# WATER DISTRIBUTION SYSTEM IMPROVEMENTS TO SERVE

## SUMMIT CROSSING 2ND ADDITION

2062 ~~2061~~ N. GARNETT STREET

### AS BUILTS

WATER LINE 1

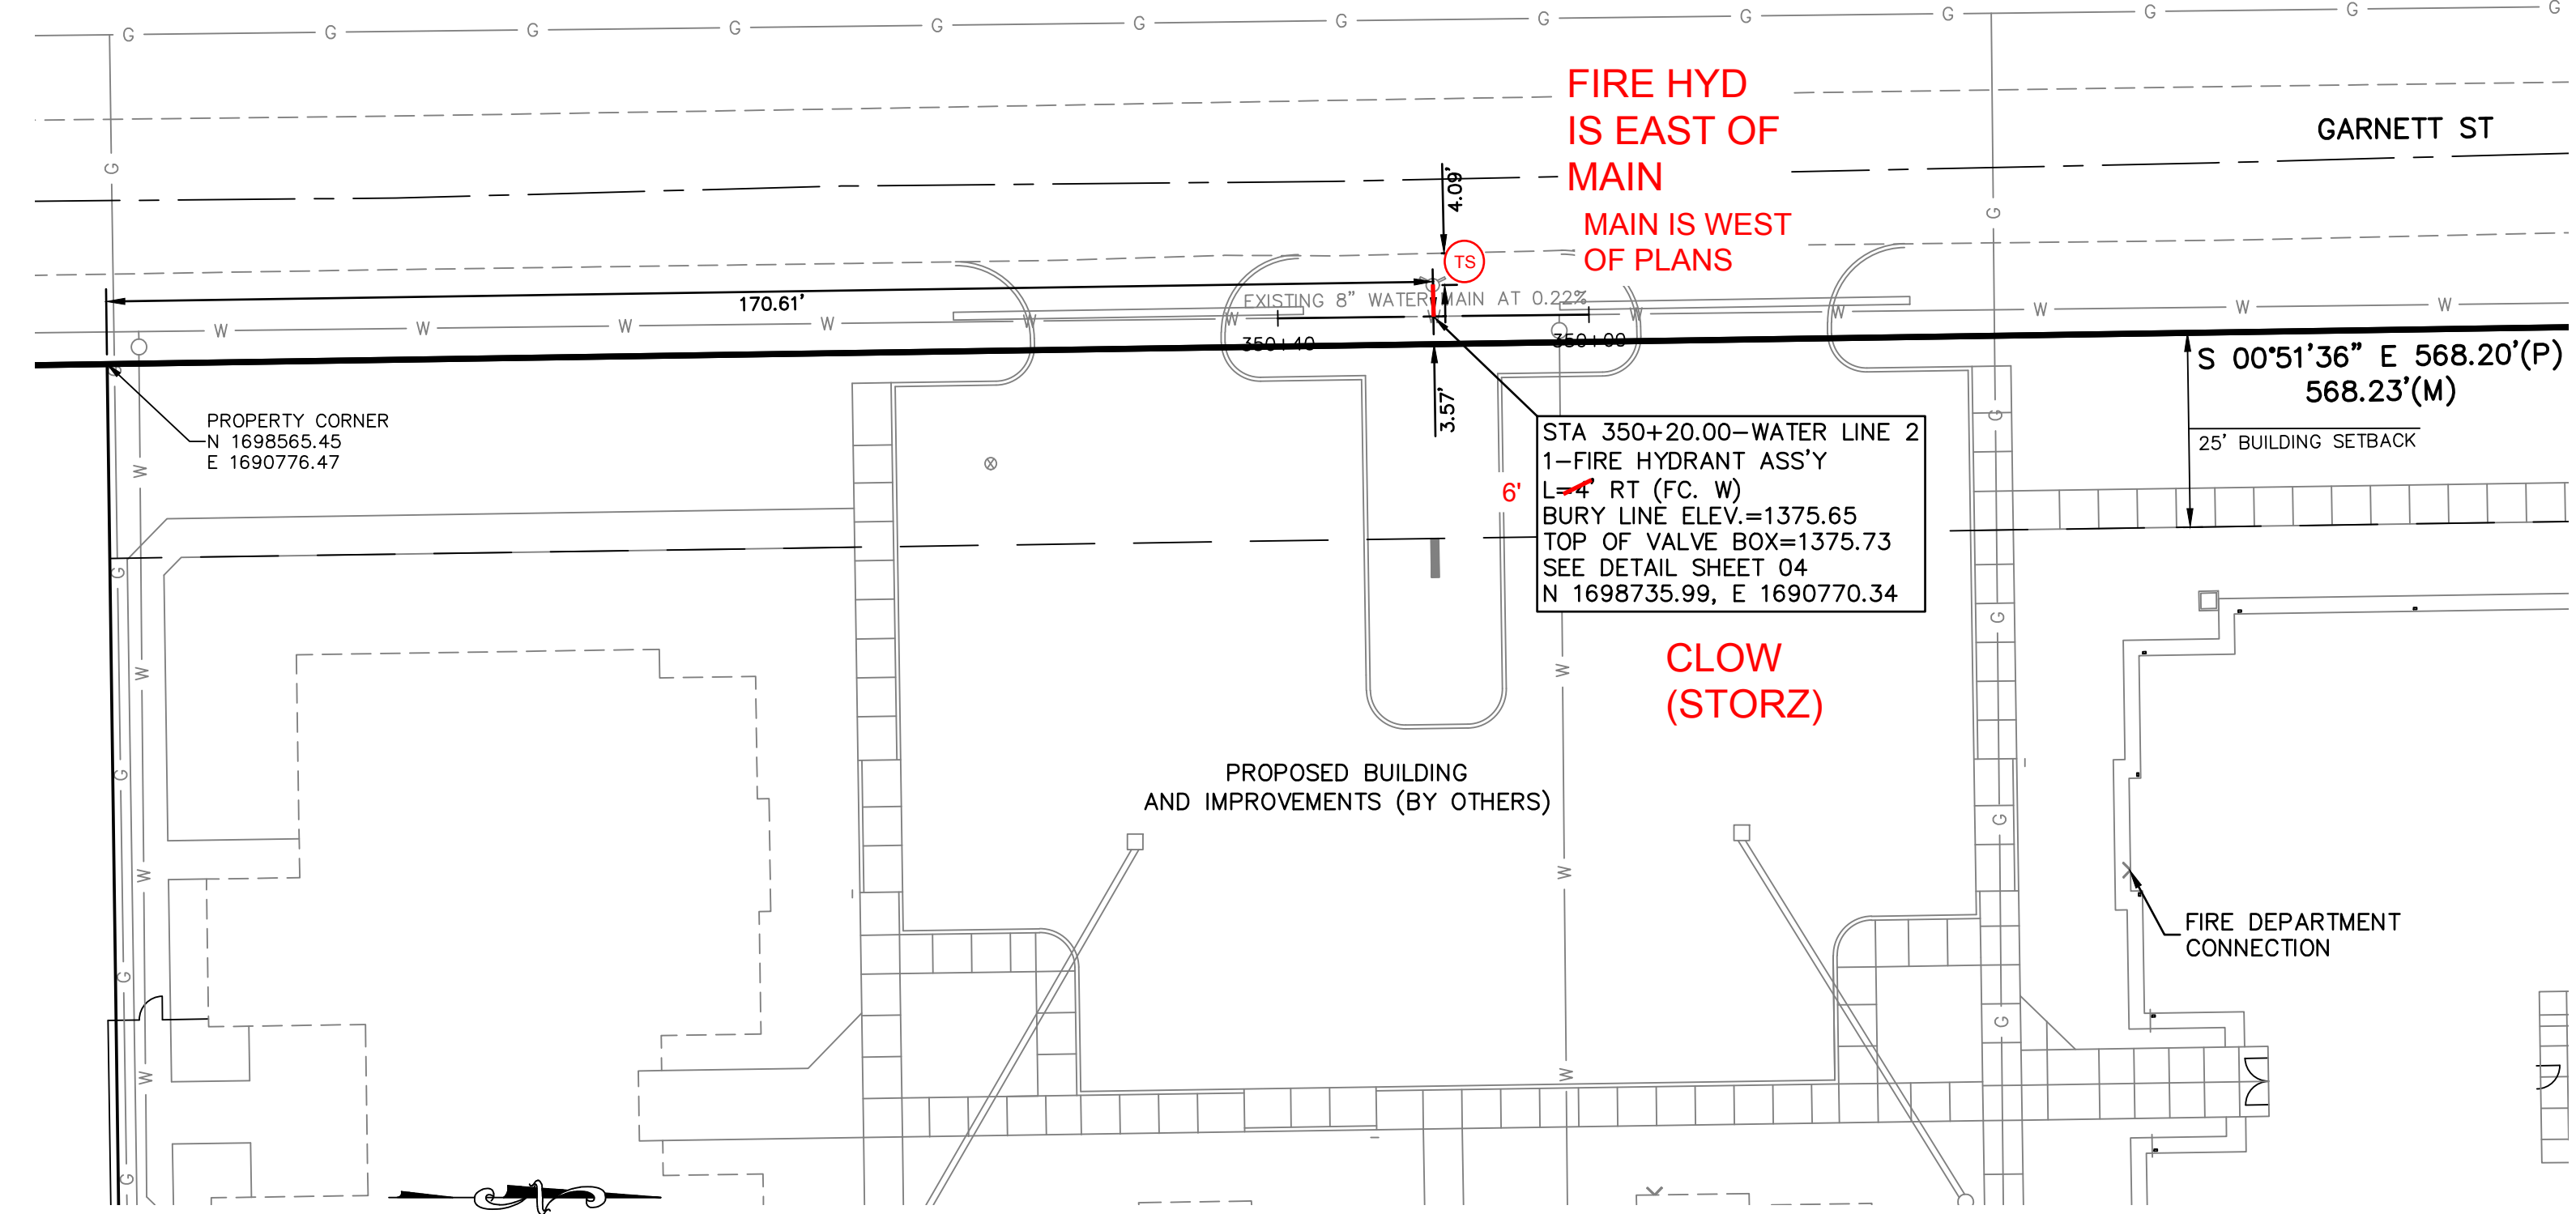
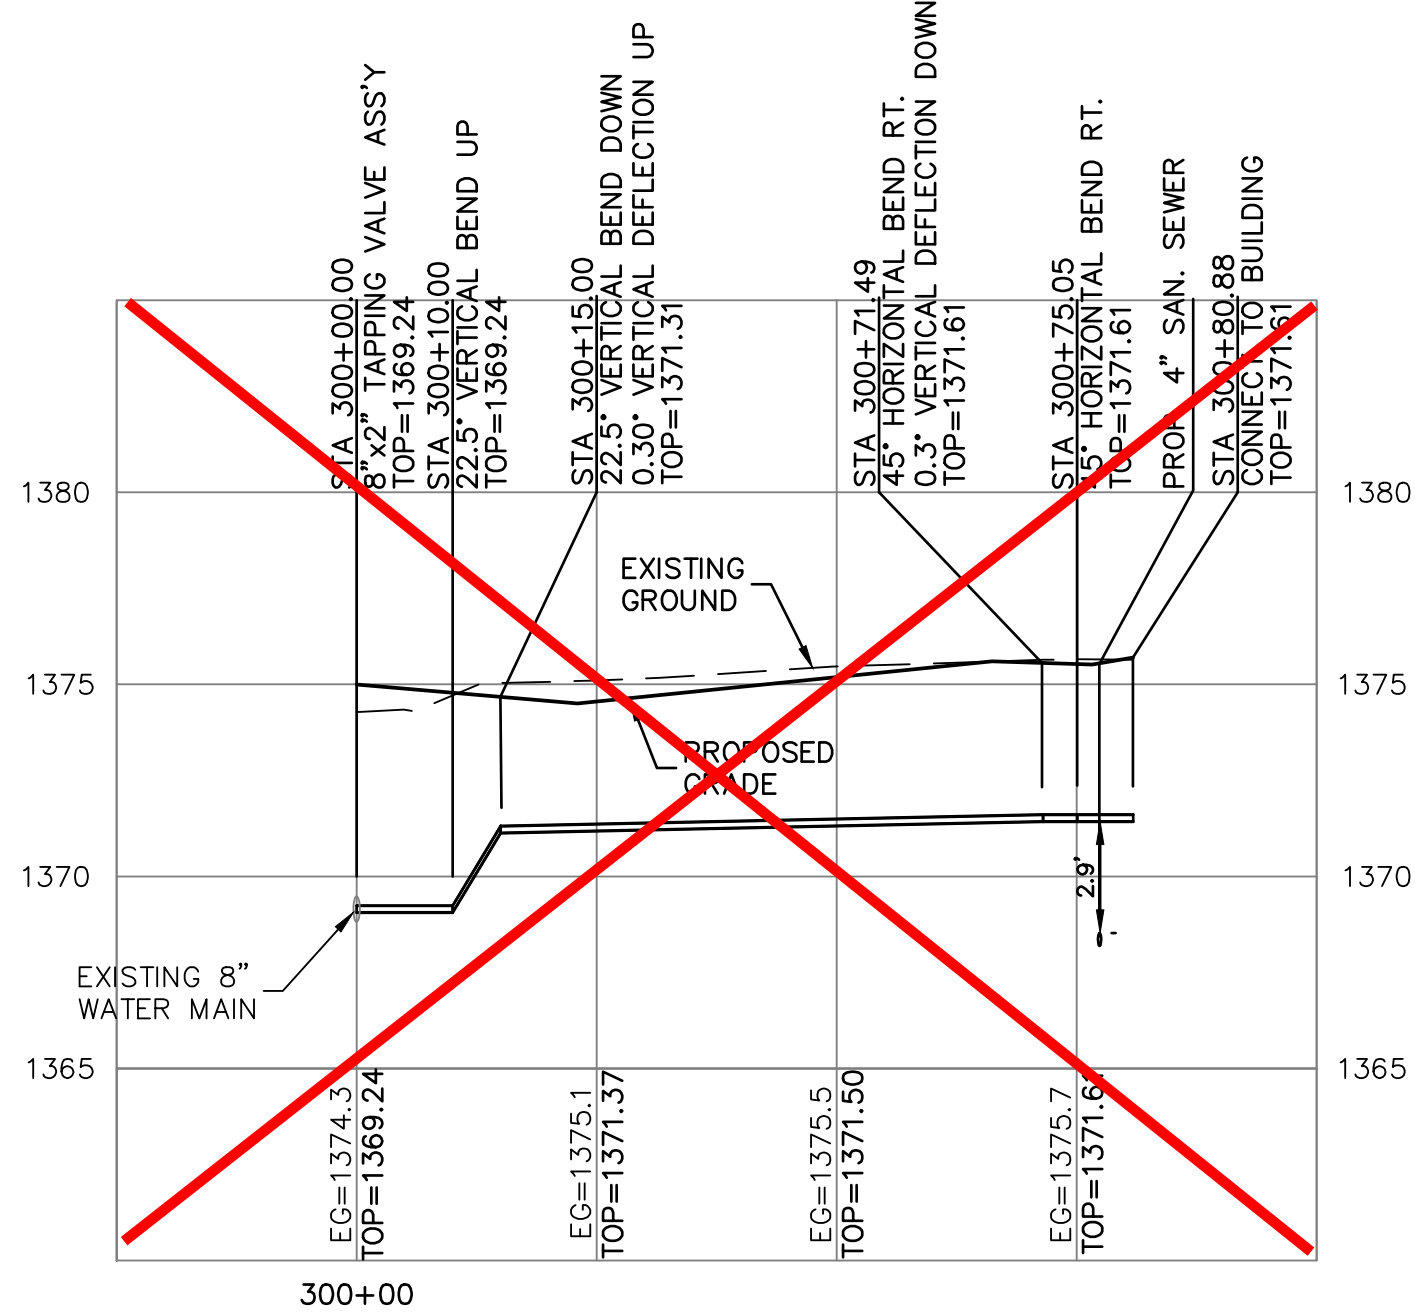
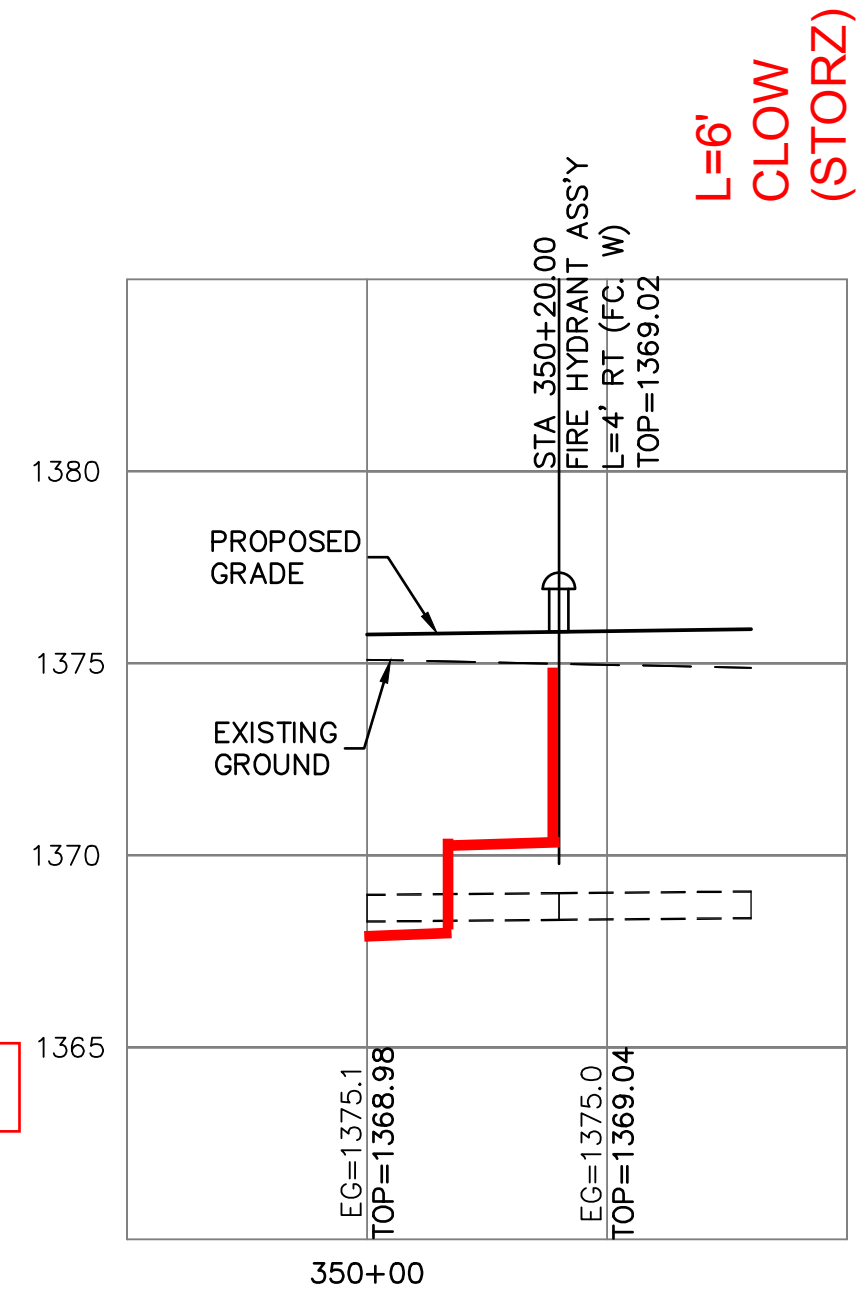
FROM CENTER OF INTERSECTION OF SHADYBROOK ST. AND GARNETT ST.

249' SOUTH ON GARNETT AND EAST 16' TO MAIN (MAIN IS 6.5' DEEP & 6' EAST OF EDGE OF ASPHALT)

FROM MAIN 1.2' EAST TO VALVE

FROM MAIN EAST 3' TO 90 DEG. BENDS

FROM CENTER OF GARNETT & SHADYBROOK 249' SOUTH AND EAST 22' TO CLOW (STORZ) FIRE HYD.

FH VB is 4' West of FH

MAIN IS 6.5' DEEP FIRE HYD IS 5' LONG

2-90 DEG BENDS VERT.

INSPECTION ON LINE 2 ONLY
